October 3, 1984
84042.030

Subject: Responses to Cygna Design Control, Pipe Support, and Pipe Stress
Questions
Comanche Peak Steam Electric Station
Independent Assessment Program - Phase 3
Texas Utilities Generating Company
Job No. 84042

COMANCHE PEAK STEAM ELECTRIC STATION
CPSES CYGNA REVIEW QUESTIONS
(PIPE SUPPORTS)

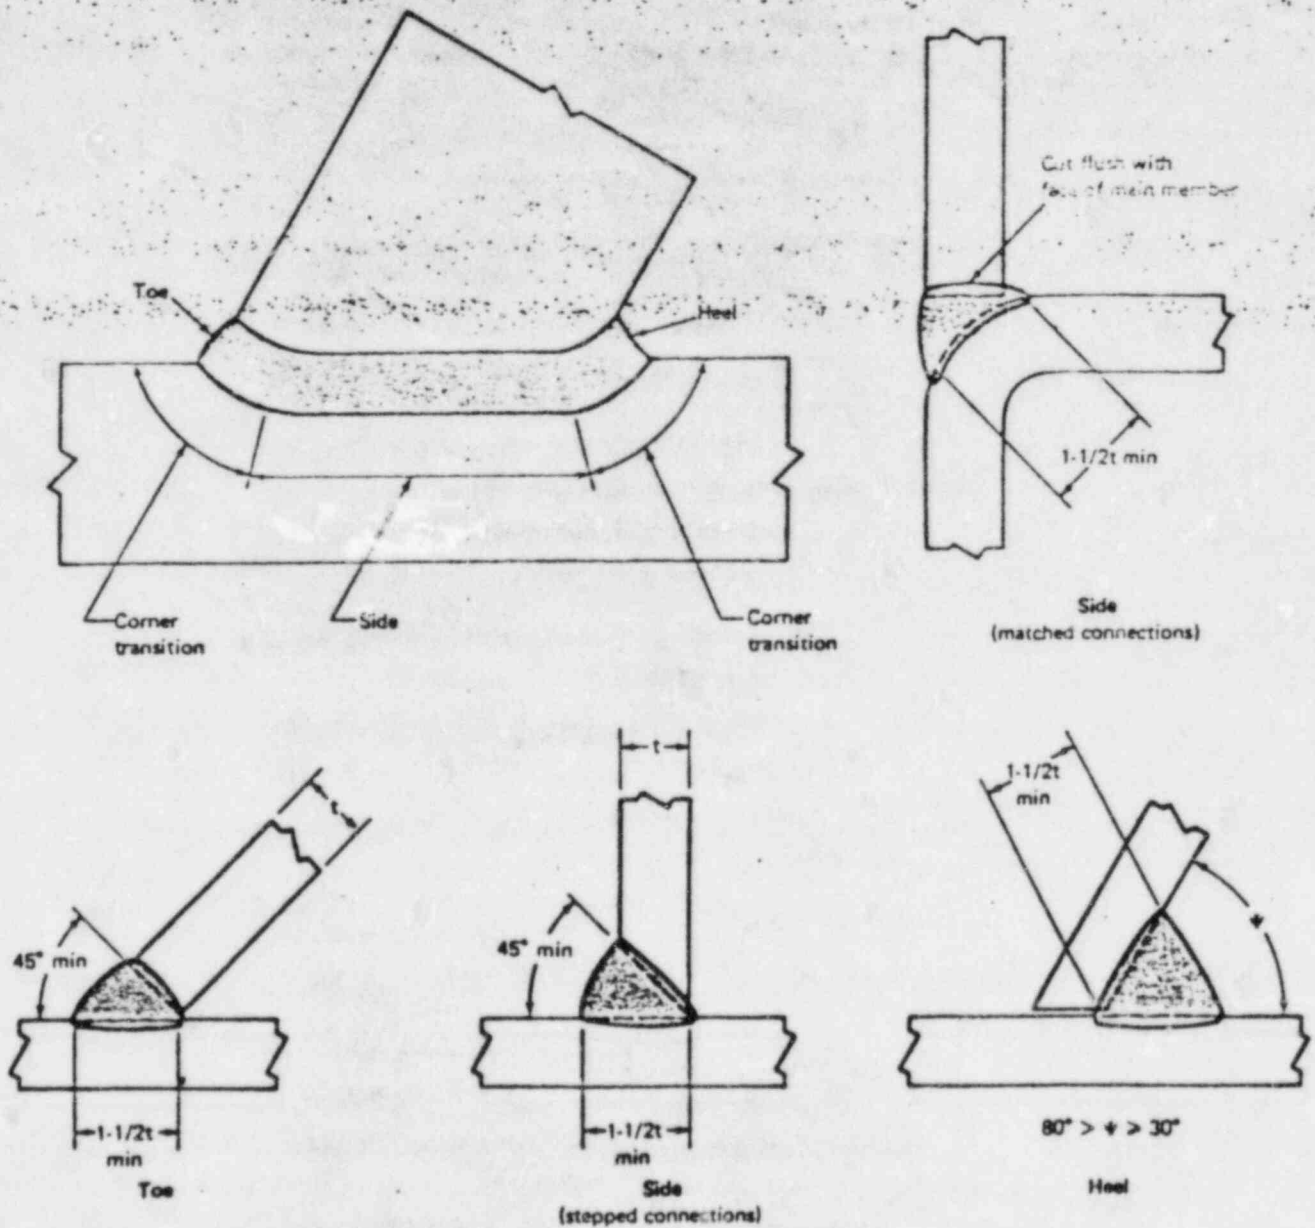
- a) It is our interpretation of existing weld standards that the effective throat of a flare bevel weld (t_e) is $5/16R$. Assuming $R=2t$, then $t_e=5/8t$. What justification does TUGCO have for using $t_e=t$ in flare bevel weld design?
- b) Please provide documentation which instructs engineers how to calculate the effective throat of a flare bevel weld with a fillet cap.

- a) Per AWS D1.1, 1979 edition, figure 10.13.1.3B, an effective throat of t is specified (see attached). Based on the geometry of the joint, $t_e=t$ is a reasonable value.*
- b) Calculation of weld effective throat (in any joint) is based on the shortest distance from the root of the weld to the face of the weld. For a flare bevel with a fillet cap, the engineer uses this approach in calculating t_e . The example supplied to CYGNA for MS-1-003-013-C72K, shows this calculation is done.

1. t = thickness of thinner section
2. Depth of bevel = t
3. Root opening 0 to 3/16 in. (4.8 mm)
4. Not prequalified for ψ under 30°
5. Effective throat = t
6. Joint preparation for corner welds shall provide a smooth transition from one detail to another.
Welding shall be carried continuously around corners, with corners fully built up and all starts and stops within flat faces.

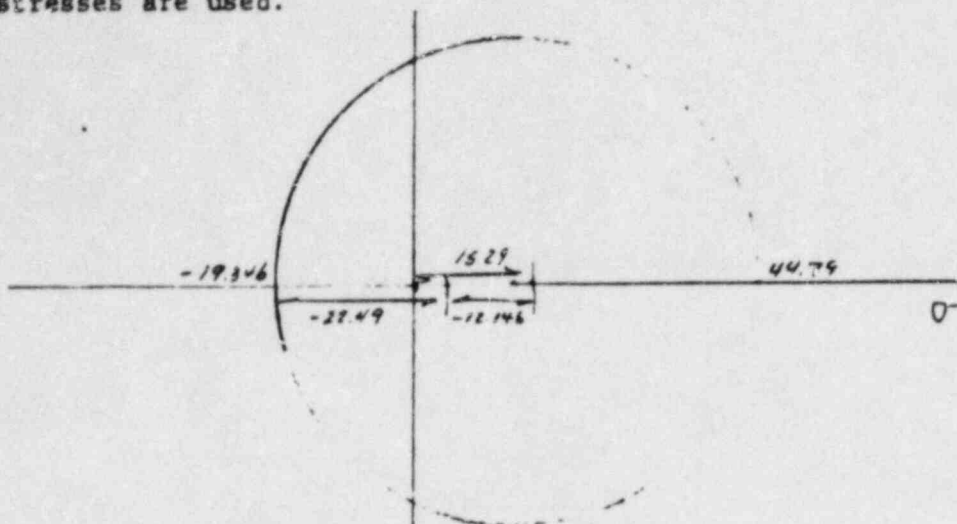
AB-1-005 - Should be AB-1-023A.

CC: ARMS (B&R Site) OL

D. Wade/G. Grace (TUGCo Site) 1L (telecopied)

Gibbs & Hill, Inc.
